ADDENDUM NO. 3

DATE: March 13, 2020

OWNER: Howard County Public School System

PROJECT: Hammond High School Renovation and Addition
Columbia, Maryland
Architect Project No. 18011

DETAILS - ELECTRICAL

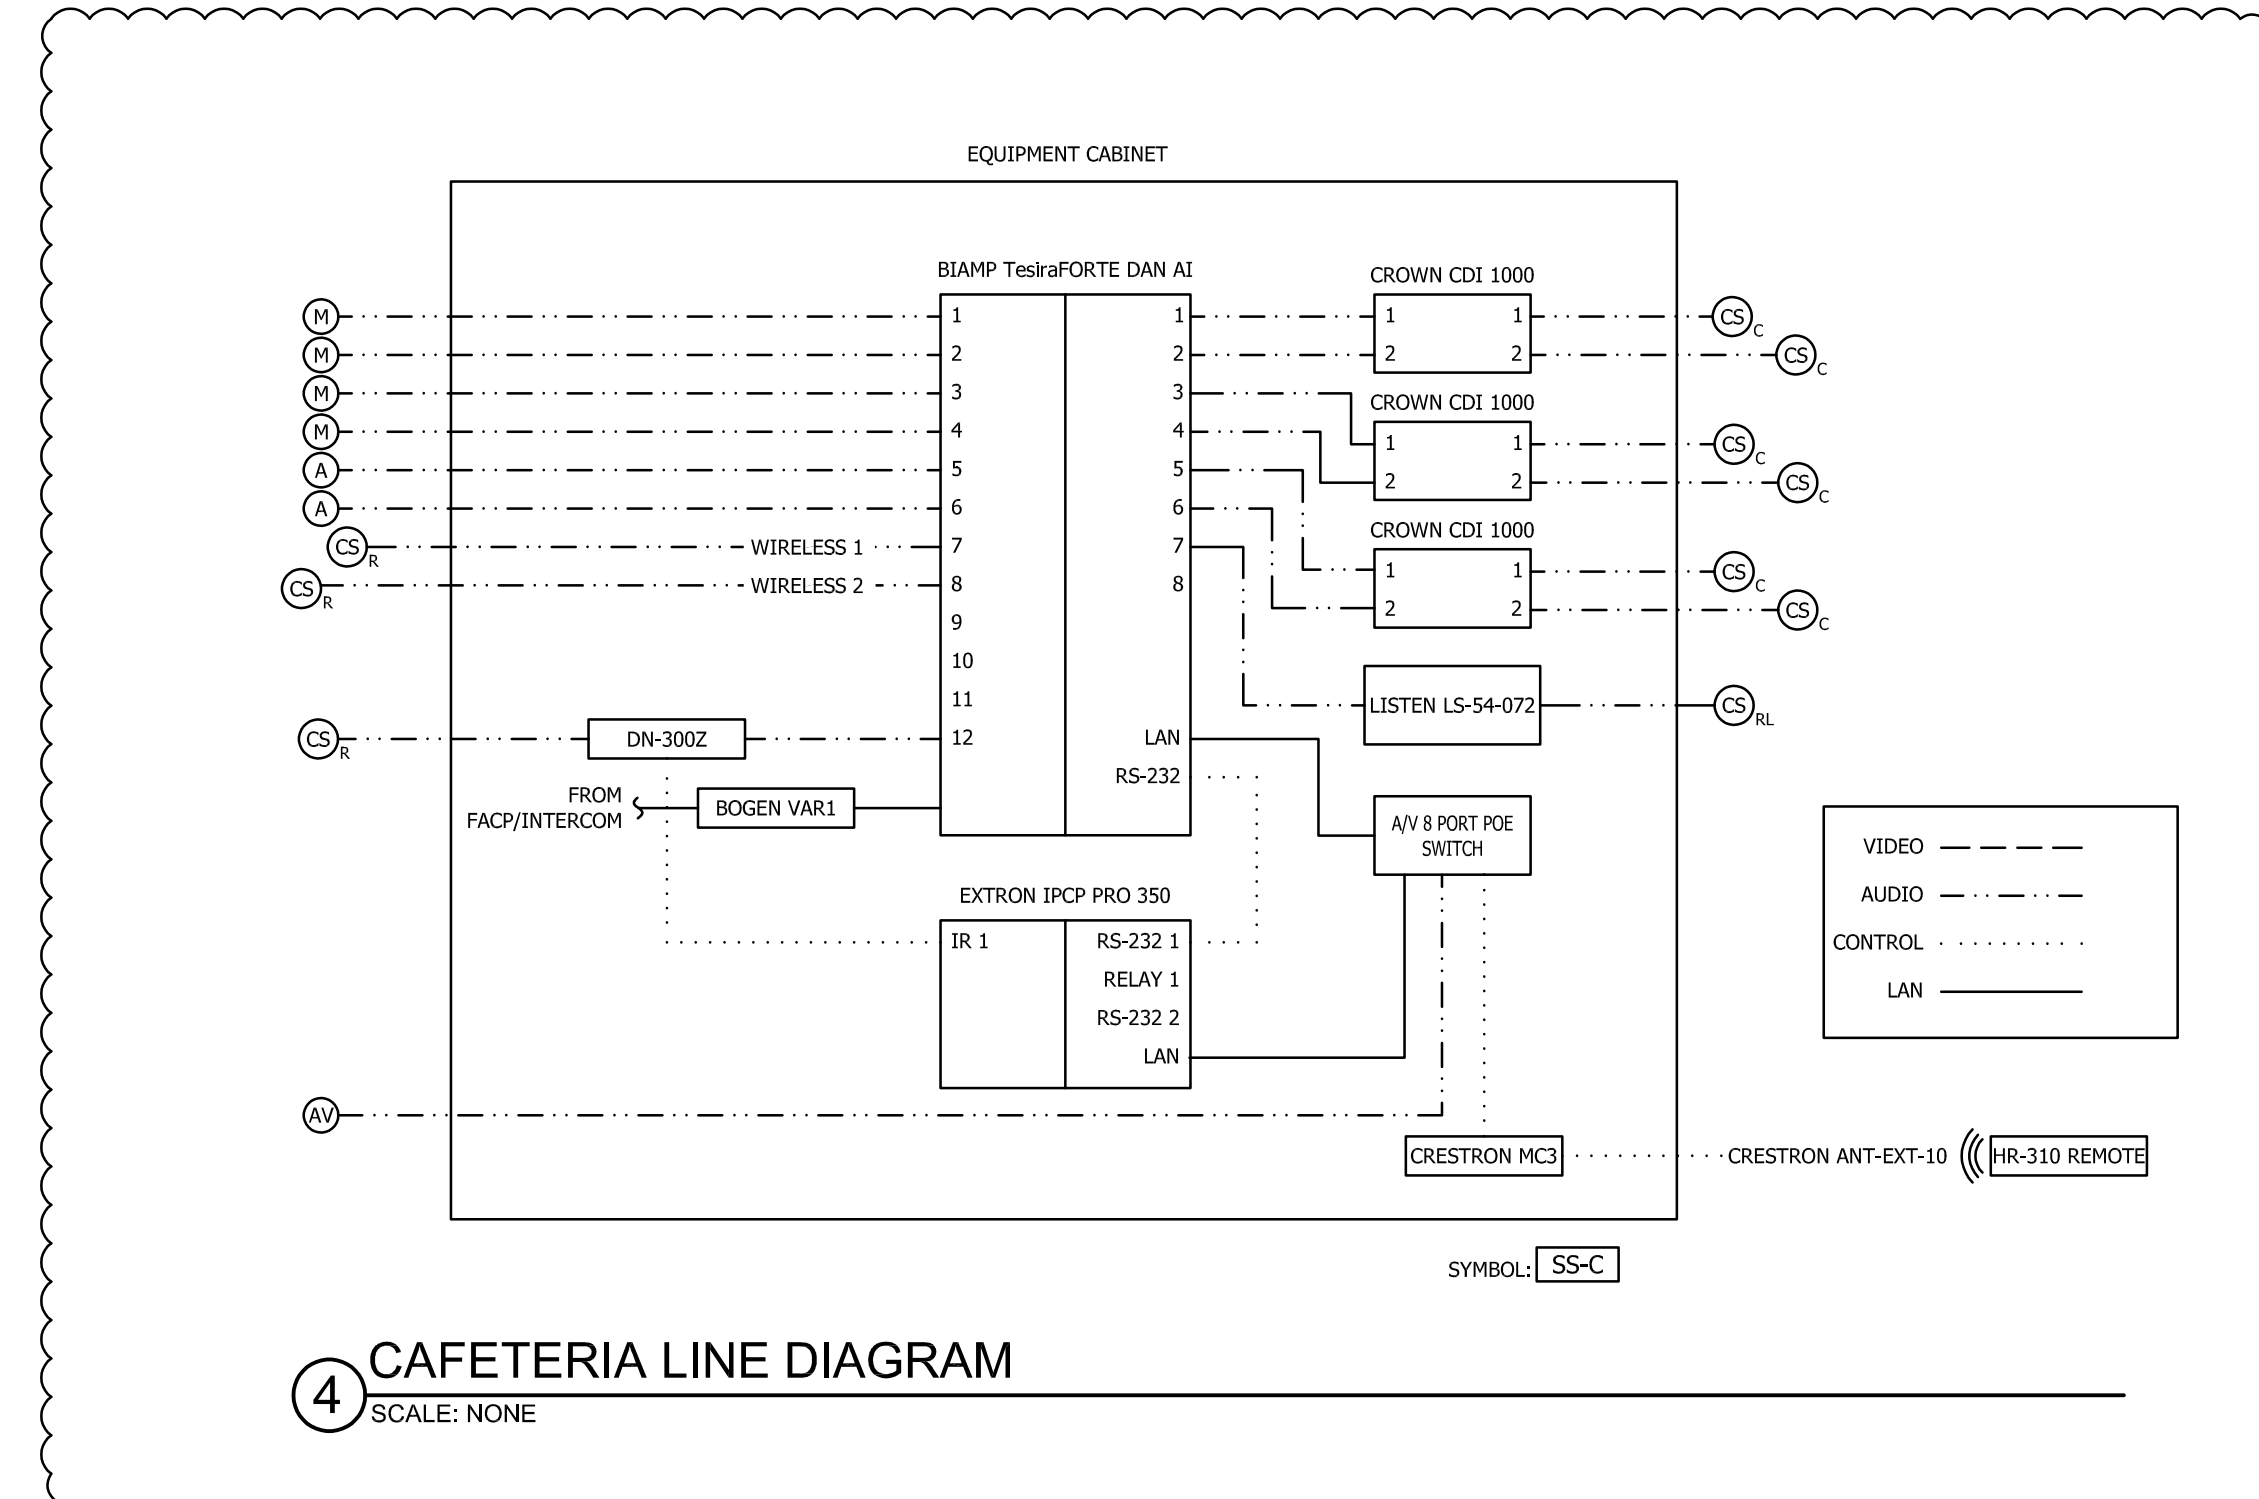
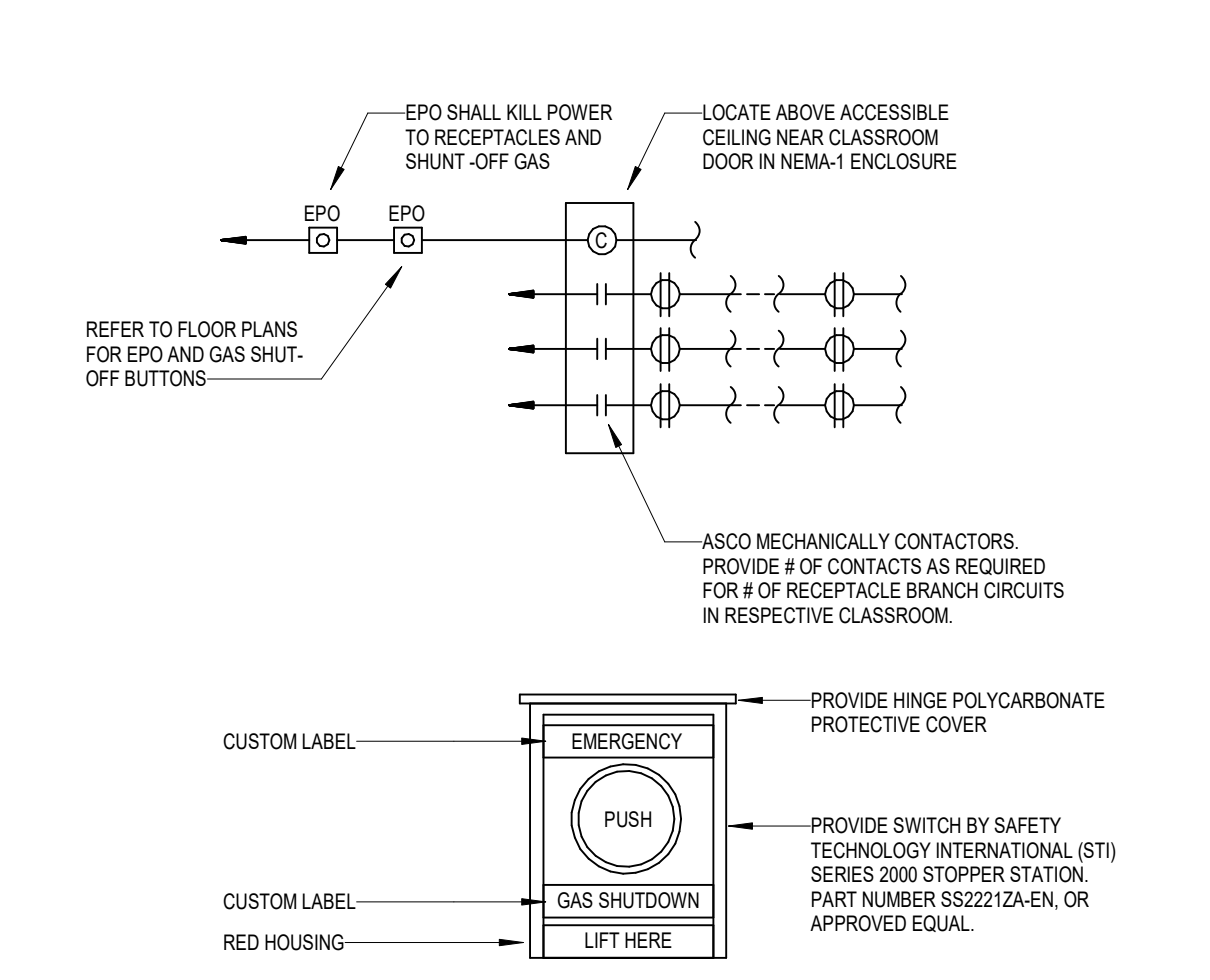
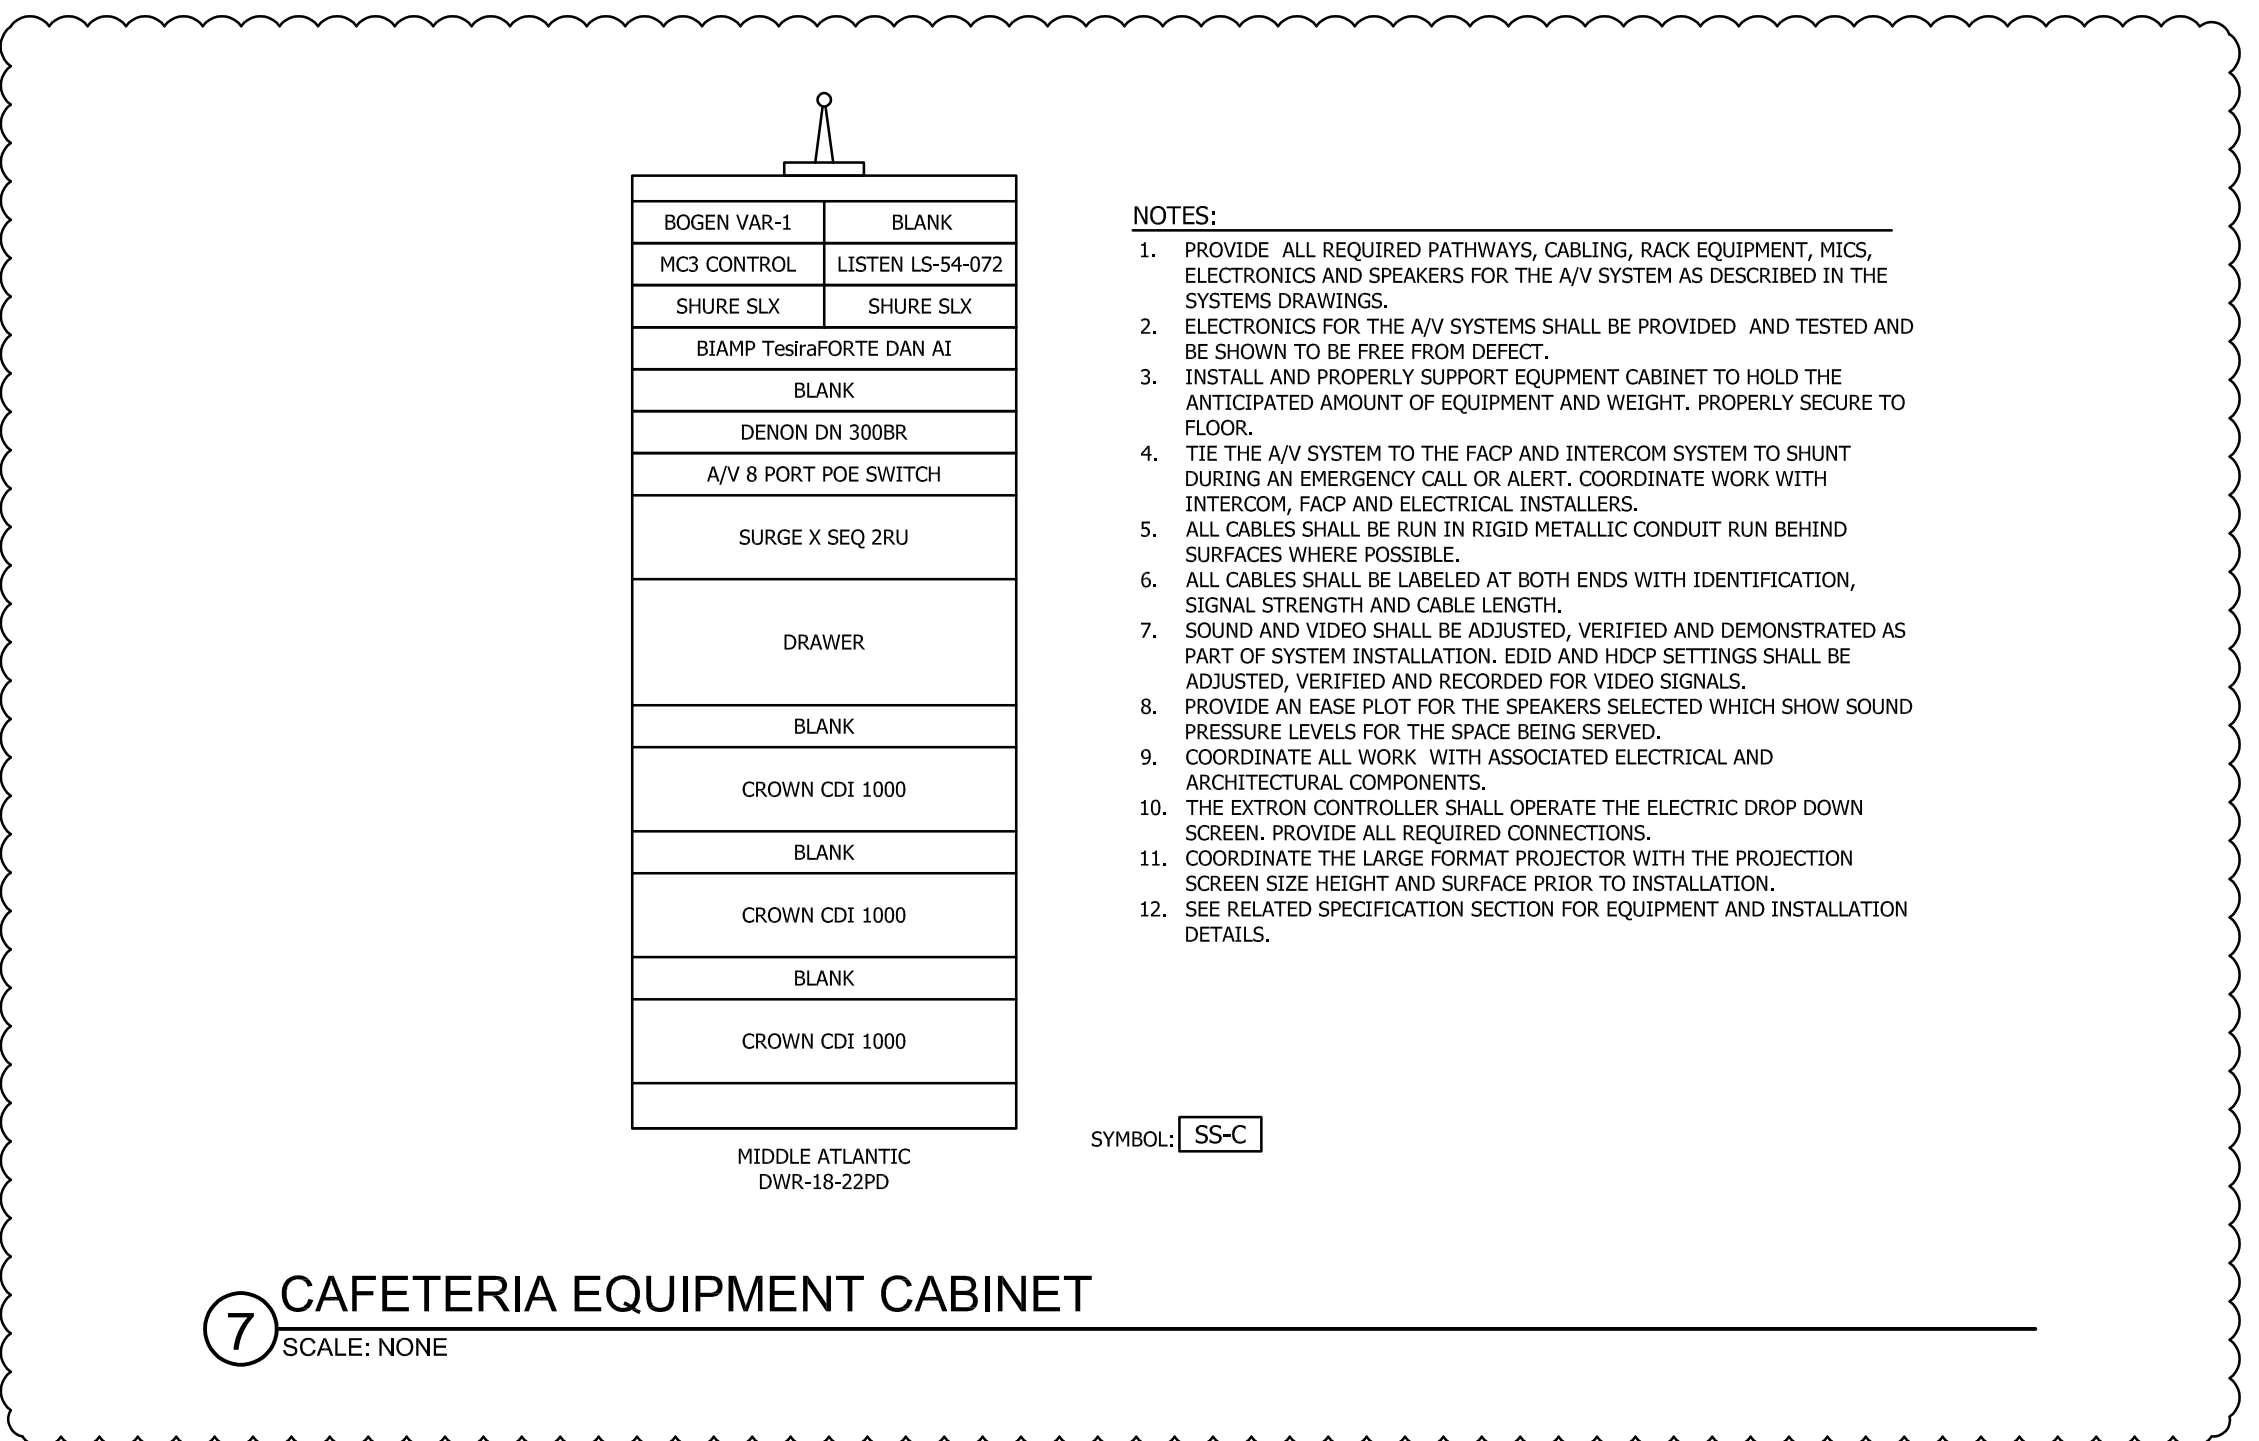
- 27L. Cafeteria/Aux Gym: Drawing E7.05 does not include provisions for the wired microphone wall plates located in these spaces

- 27M. The ceiling speaker coverage in the cafeteria shown using Sound Enhancement speakers may be insufficient in noisy environments. (Drawing E4.03)

- Sheet E7.00 – Details – Electrical
 - **REPLACE SHEET** – Revisions to Luminaire schedule.
- Sheet E7.06 – Details – Electrical
 - **REPLACE SHEET** – AV details added.

RESPONSE: Addendum #3 has additional details on sheet E7.06.

RESPONSE: Addendum #3 has additional details on sheet E7.06.
